Monthly Specification Update

Intel® Server Board S500VSA SATA

Intel Order Number E57949-004

November, 2009

35. Intel® Server Board S5000VSA (all versions) with BIOS 79 when ghosting to or from the server with GSS2 (and older versions of ghost) appears to not be able to connect to the server

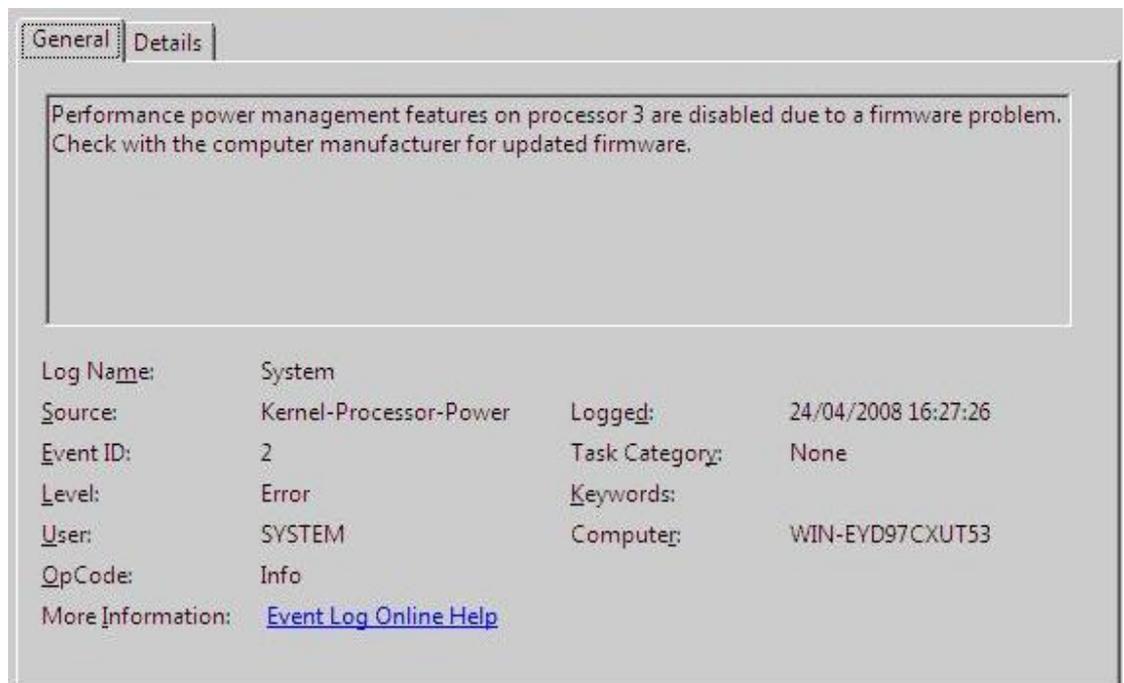
Problem: When the Intel® Server Board S5000VSA (all versions) with BIOS 79 is ghosting to or from the server with Galaxy Software Services and older versions of ghost, may not connect to the server.

Implication: Customer cannot connect to the server when ghosting to or from the server. This is a NIC detection issue under DOS.

Status: Intel will fix this issue in BIOS 83.

Workaround: Not available at this time. Please wait for BIOS 83.
